Access Compliance Report Public Rights-of-Way (Curb Ramps)

Main Street: DEAN_ST Cross Street: BLUEBERRY_WAY Location: W

ADA ID: RPAT211109141014 Ramp Type: Type 1 - Perpendicular Diagonal Initial Pass/Fail: Pass Overall Compliance: No Severity Score: 0

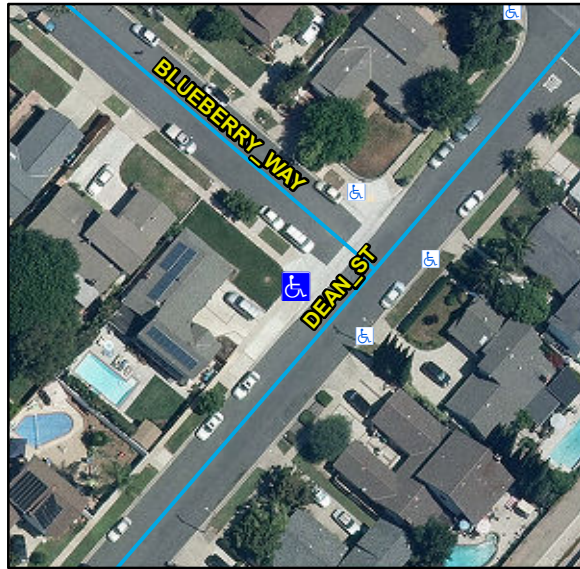
R304.2.2, R304.2.1, STD 1115

Compliance	Description	Data	Compliance	Description	Data
N/A	Ramp Length (in)	88	N/A	Flare Type LT	
Yes	Ramp Width (in)	49			Sloped
Yes	Ramp Run Slope (%)	6.8	N/A	Flare Slope LT (%)	4
Yes	Ramp Cross Slope (%)	0.1	N/A	Flare Traversable LT	No
N/A	Landing Present	Yes	N/A	Flare Type RT	
N/A	Landing Length (in)	50			Sloped
Yes	Landing Width (in)	49	N/A	Flare Slope RT (%)	5.9
Yes	Landing Run Slope (%)	0.7	N/A	Flare Traversable RT	No
Yes	Landing Cross Slope (%)	1	Yes	DWS Provided	Yes
N/A	Landing Movement Obstructed?	Yes	Yes	DWS Contrast	Yes
	Landing Movement Type	wall	Yes	DWS Length (in)	36
N/A	Landing Shared	No	Yes	DWS Full Width	Yes
N/A	Clear Space	Yes	Yes	DWS Offset Left (in)	0
N/A	Clear Space To Crosswalk (in)	48	Yes	DWS Offset Right (in)	N/A
N/A	Marked Crosswalk 1	No	N/A	Marked Crosswalk 2	No
	Crossing 1 Direction	SE		Crossing 2 Direction	NE
	Marked Crosswalk 1 Width (in)	N/A		Marked Crosswalk 2 Width (in)	N/A

N/A	Ramp Inside Crosswalk 1	N/A	Yes	Ramp Inside Crosswalk 2	N/A
	Crossing 1 Slope (%)	5.1		Crossing 2 Slope (%)	2.7
	Crossing 1 Cross Slope (%)	1.1		Crossing 2 Cross Slope (%)	1.9
Yes	Gutter Ponding	No	No	Curb Slope	8.8
Yes	Gutter Lip Height (in)	0		Road Run Slope (%)	2.2
Yes	Gutter Run Slope (%)	2		Road Cross Slope (%)	2.1
Yes	Gutter Cross Slope (%)	1.5			
Yes	Overall Surface Condition: Acceptable		Yes	Perp Joint Present	Yes
	Cross Gutter Present?	Yes		Spandrel Present?	Yes
	Replace Cross Gutter?	No		Replace Spandrel?	No

Remove & Replace Curb Ramp With Two New Directional Ramps or Equivalent.
